South East Aylesbury Link Road (SEALR) Phase 2

Consultation Response Document

Date: 9 April 2021

1: This picture shows the transport links in Stoke Mandeville that are provided by the SEALR project. It also includes the existing transport links in the area around the project.

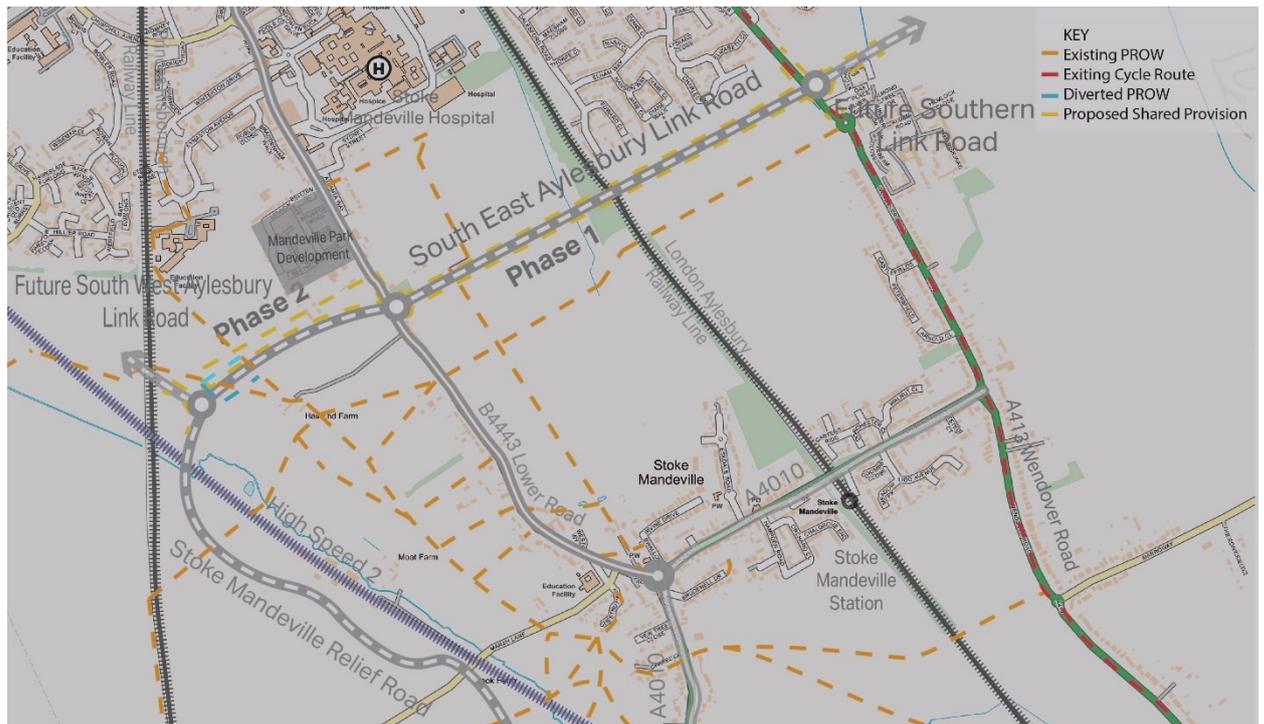
f. I am concerned that the SEALR cuts Stoke Mandeville Parish in half.

The SEALR will provide several new roundabouts that will improve connectivity in Stoke Mandeville Parish. The project will provide additional cycling and walking infrastructure. Public Rights of Way impacted by either Phase of the SEALR will be diverted. The transport links provided by the SEALR, as well as the existing links, can be seen on the plan below.
